Service Bulletin

Bulletin No.: 20-NA-063

Subject: SD Card Removed Error Message Displayed on Instrument Panel Cluster (IPC)

| Brand: | Model: | Model Year: | | VIN: | | Engine: | Transmission: |
|----------|--------|-------------|------|------|----|---------|---------------|
| Cadillac | XT4 | 2019 | 2020 | — | — | All | All |

5537651

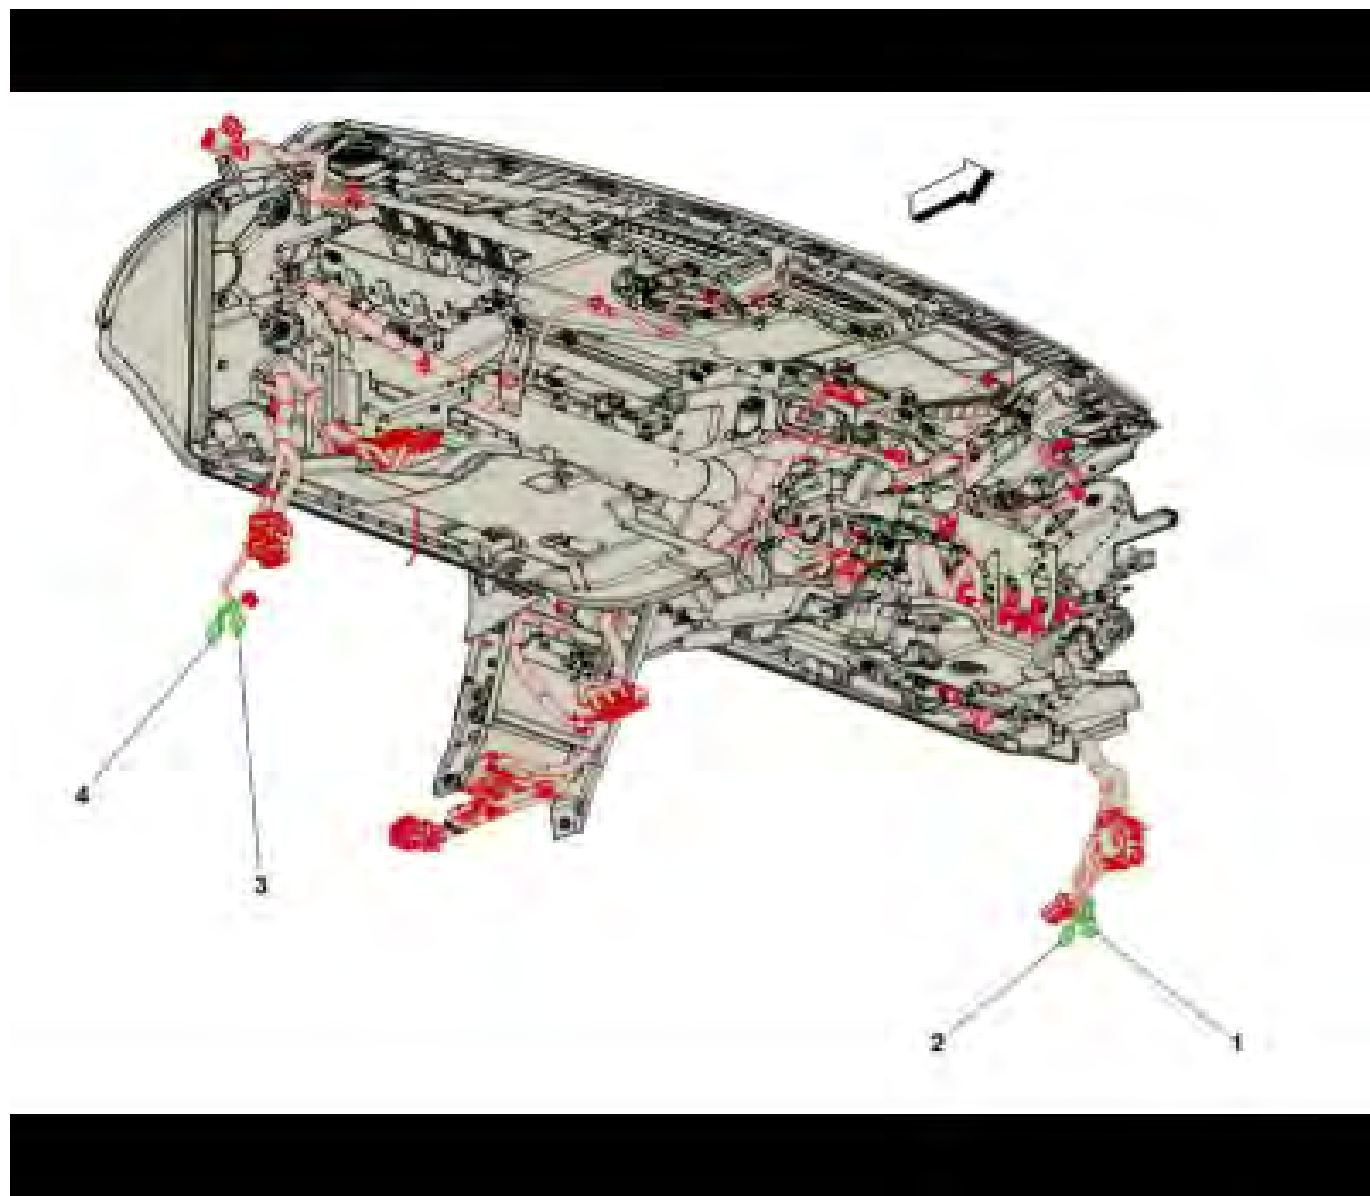
1. Partially remove the USB HUB (1). Follow the *Multimedia Receptacle Replacement* in SI to get to the back and locate the USB HUB ground wire.

5537654

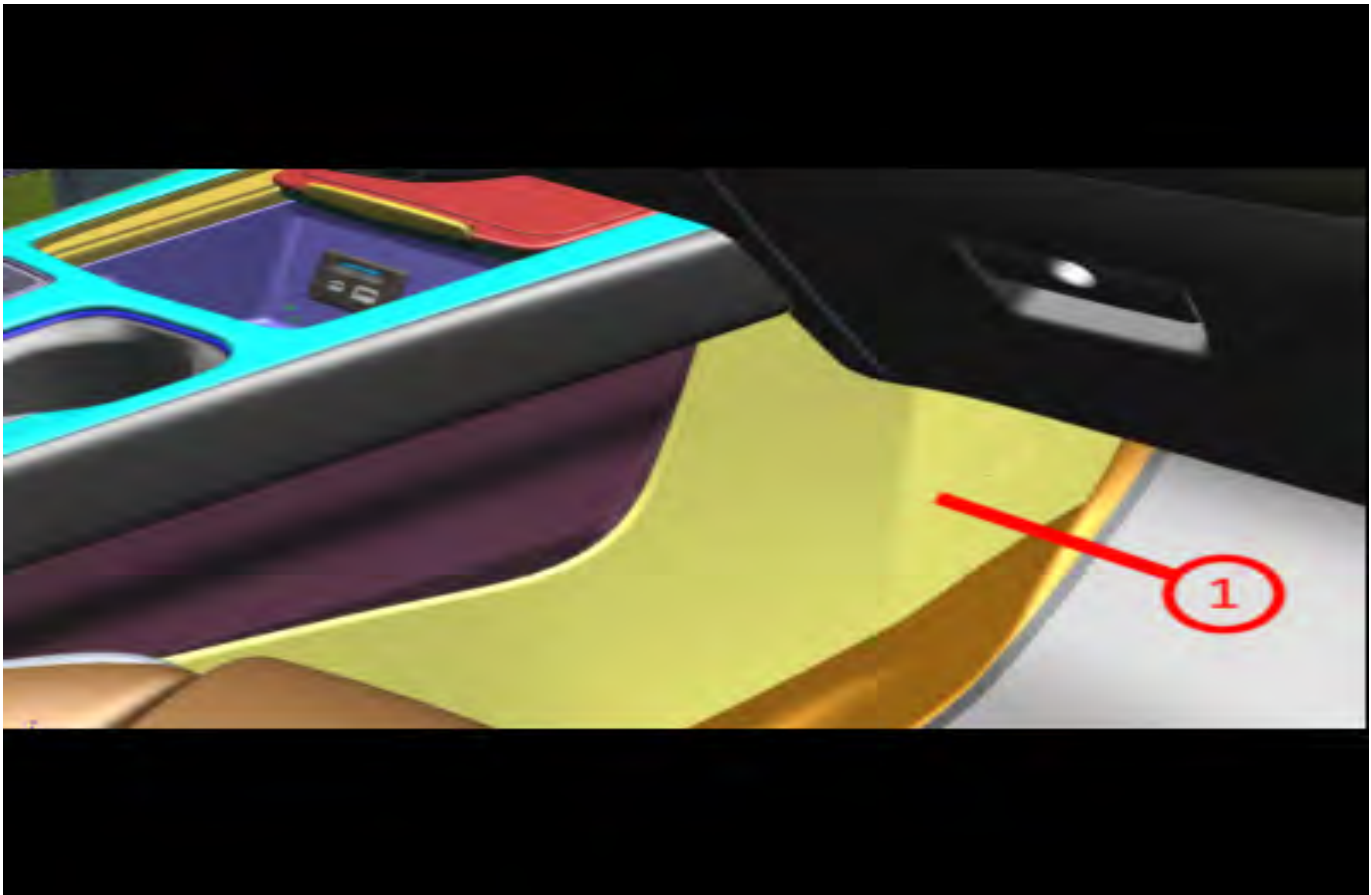
2. Cut the terminal 3 black ground wire from the USB HUB and butt connect to the USB HUB a new 0.75 mm jumper wire about 2600 mm (8.5 feet) in length. Run the wire behind the instrument panel and carpet to Ground 202 (3), located on the passenger side of the vehicle. Cut back and tape off the original ground wire with electrical tape.

5537661

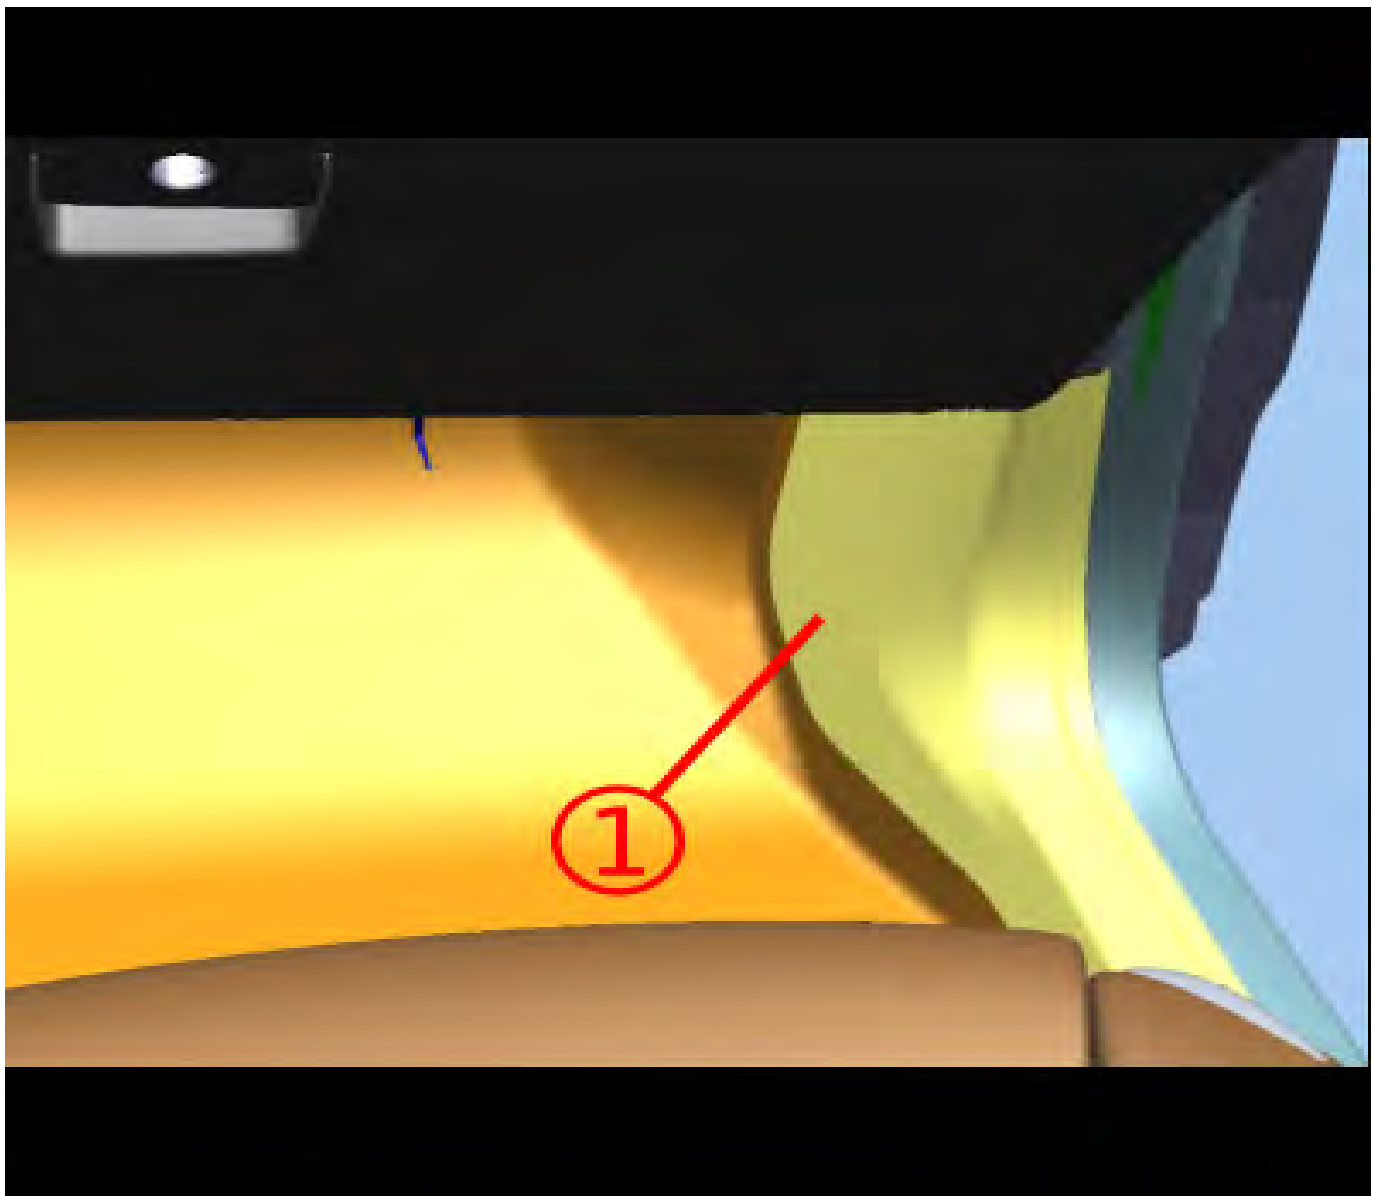
3. The front floor console extension panel (1) needs to be removed to gain access to the running wire. Refer to *Front Floor Console Extension Panel Replacement - Right Side* in SI.

5537664

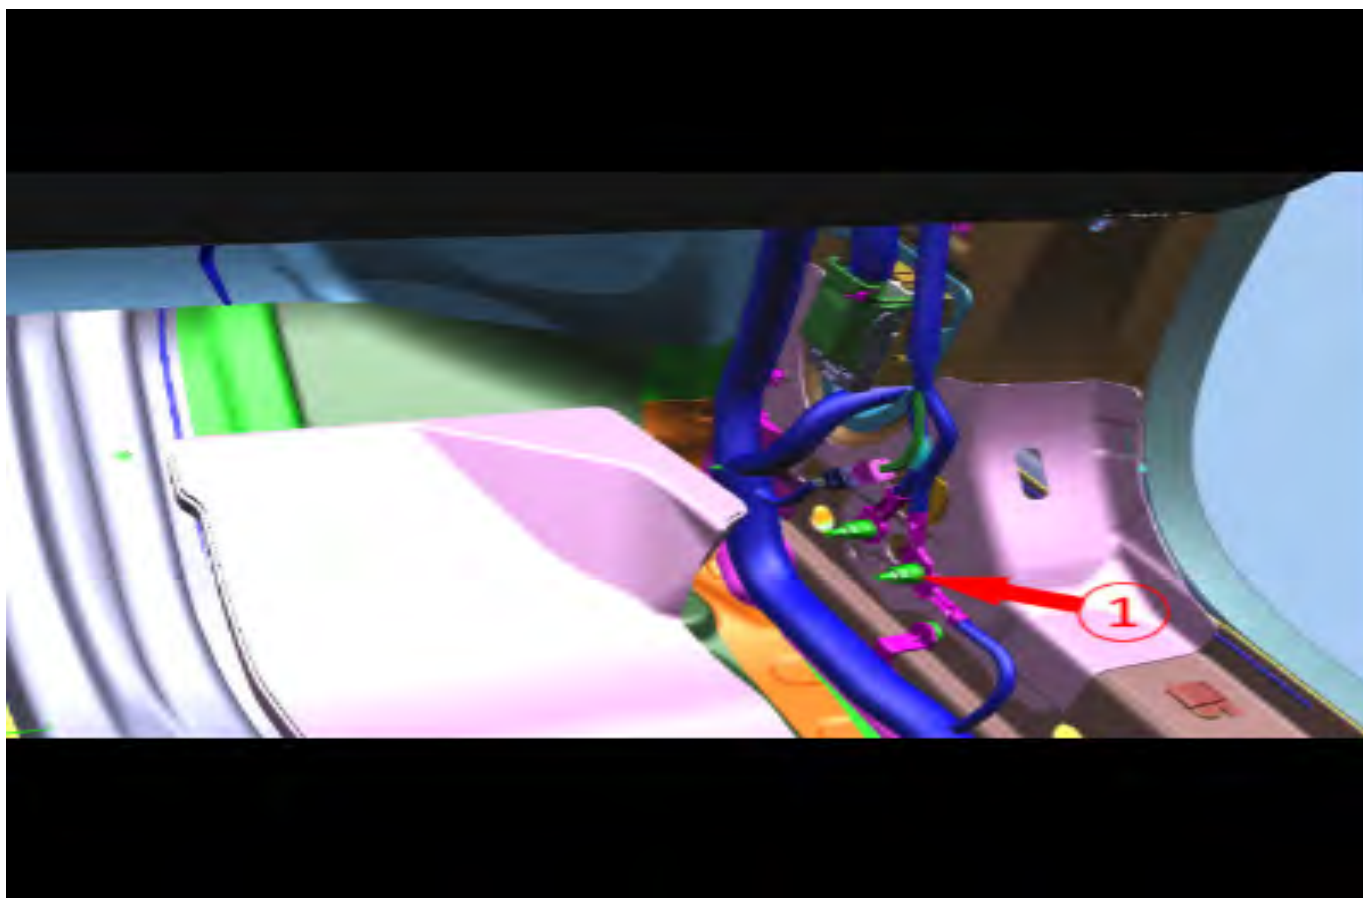
4. The front passenger-side door sill panel (1) needs to be removed to gain access to the running wire. Refer to *Front Side Door Sill Garnish Molding Replacement* in SI.

5. Pull back the carpet, install a new ground ring to the new ground wire and attach to G202 (1). The ground terminal fits an M8 stud.
6. Reposition carpet and reinstall the front passenger-side door sill panel. Refer to *Front Side Door Sill Garnish Molding* and the front floor console extension panel. Refer to *Front Floor Console Extension Panel Replacement - Right Side* in SI.
7. Once the wire has been installed, reinstall the USB HUB. Refer to *Multimedia Receptacle Replacement* in SI and verify that the SD Card Removed message no longer displays on the IPC.
